Package Modeling and Return Loss Limits

IEEE802.3bj Geneva Interim
September 2012

Richard Mellitz – Intel
Mike Peng Li – Altera
Liav Ben-Artzi - Marvell

Comment 130: Risetime filter

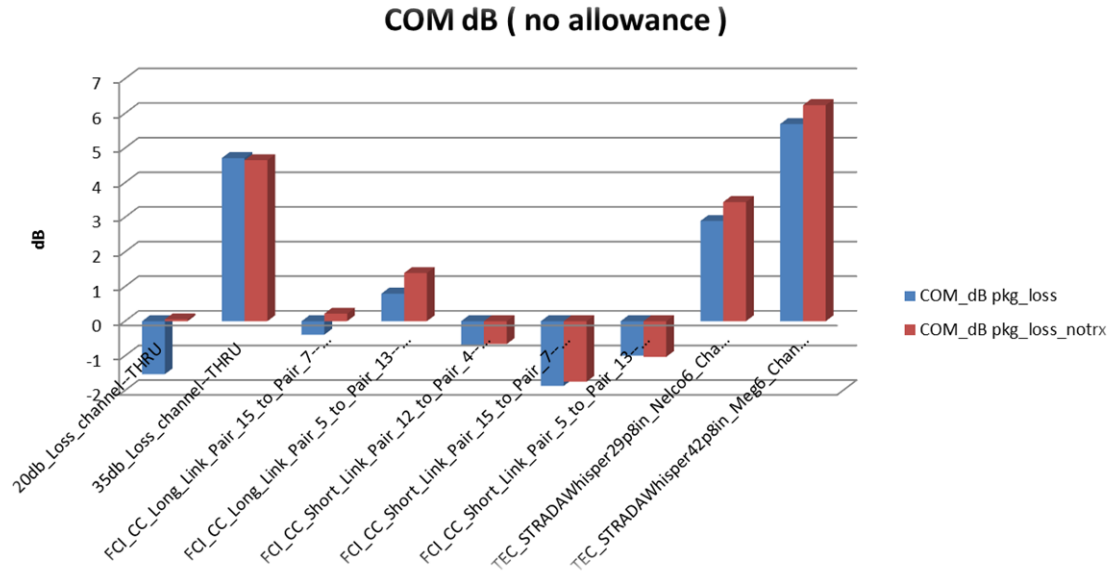
- It can be seen that when the package is considered in the channel rise time impact is < 1 dB of COM on passing channels
- $\Gamma = 0.315$ F=.8Fb package model and h21(f) proposal 1 used
- Added pkg. loss to through and crosstalk channels
- Recommendation: Keep risetime filter.

- Comment 130 (double counting rise time filtering)
 - Recommend: Keep tx filter
- Comments 168 & 169 & 422 (package return loss model)
 - Correct Equations 93-a3 and 93-a4 to follow eq. on slide 11 and Mellitz_01_0712 slide 13 which are equivalent (reasoning on slide 19)
 - Recommend: Use corrected equation 93a-3 with $\Gamma = 0.315$; $F1 = 0.8Fb$
- Comment 167 & 171 (measured return loss limit @TP0a / TP5a)
 - Recommend: Use eq. of slide 11 with the following values: $\Gamma = 0.35$; $F1 = 2.35$
- Comment 170 & 422 – (Package insertion loss model)
 - Recommend: Add package insertion loss equation according to slide 7 with coefficients according to slide 8.

Package Suggested Return Loss TP0a Limit.

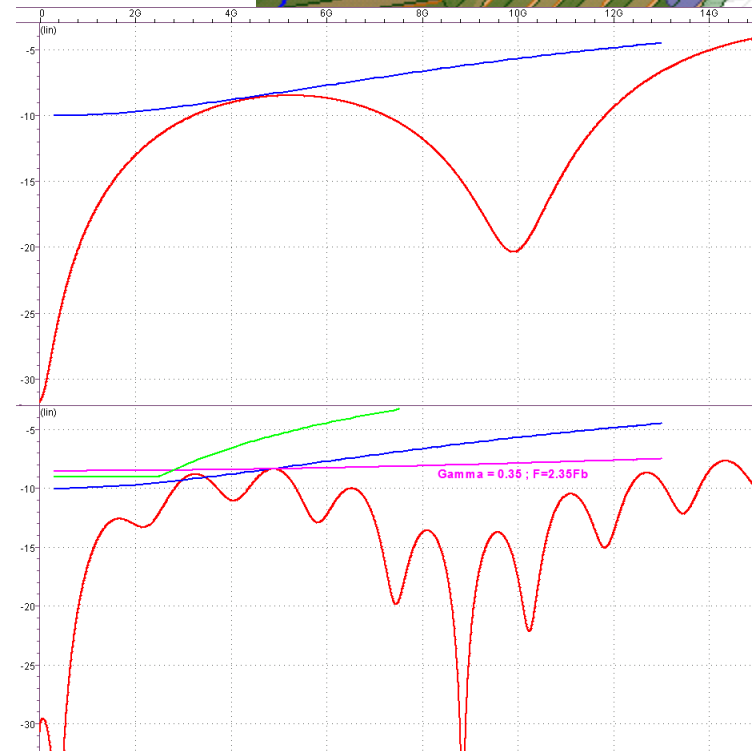
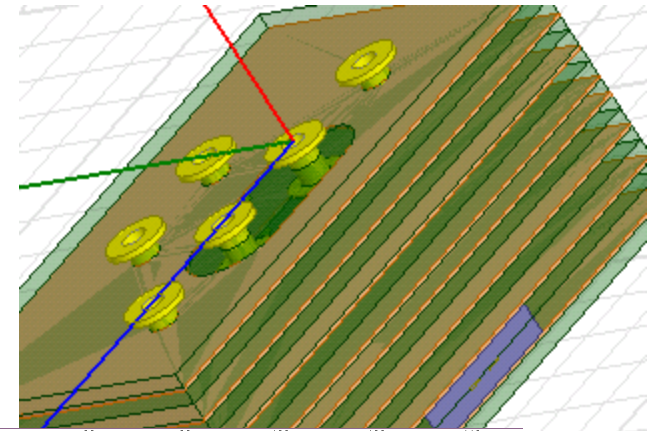
- Recommend measured return loss limit as measured through a fixture that correlates to BenArtsi_01_0912
 - $\Gamma = 0.35$
 - $F = 2.35F_b$
- Low frequency updated upward to allow multi-reflection between chip and interconnect.
- High frequency updated downward to account for fixture loss.
- Correlates to ($\Gamma = 0.315$, $F_1 = 0.8F_b$) on device pins.

Why Fix Eq. 93-A3

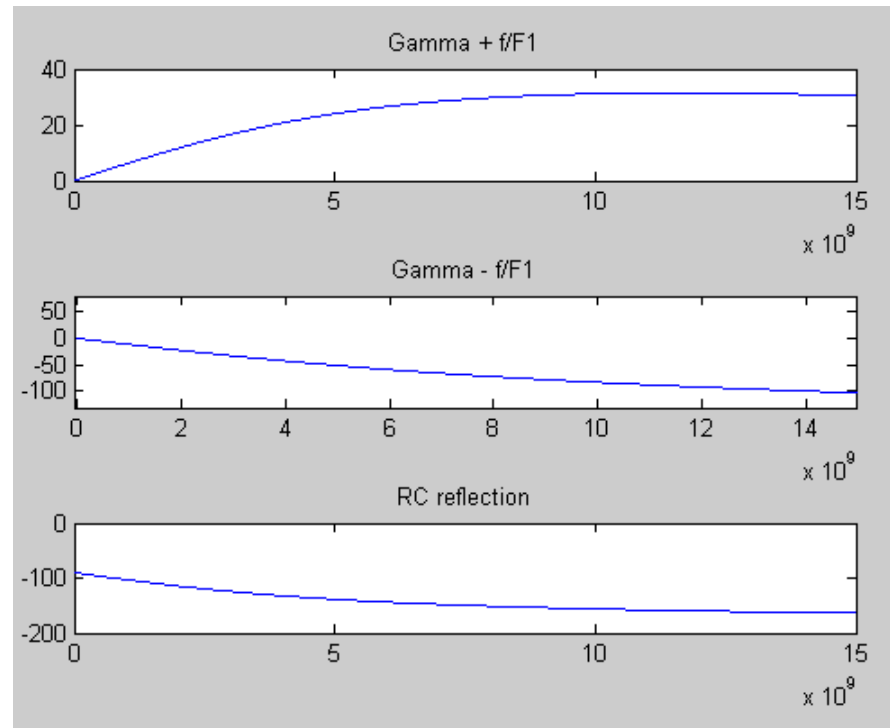
- To get the phase to behave similarly to reflection from a capacitive load change:

$$RL = \left(\frac{\text{Gamma} + \left(i \frac{f}{F1} \right)}{1 + \left(i \frac{f}{F1} \right)} \right)$$

to:

$$RL = \left(\frac{\text{Gamma} - \left(i \frac{f}{F1} \right)}{1 + \left(i \frac{f}{F1} \right)} \right)$$
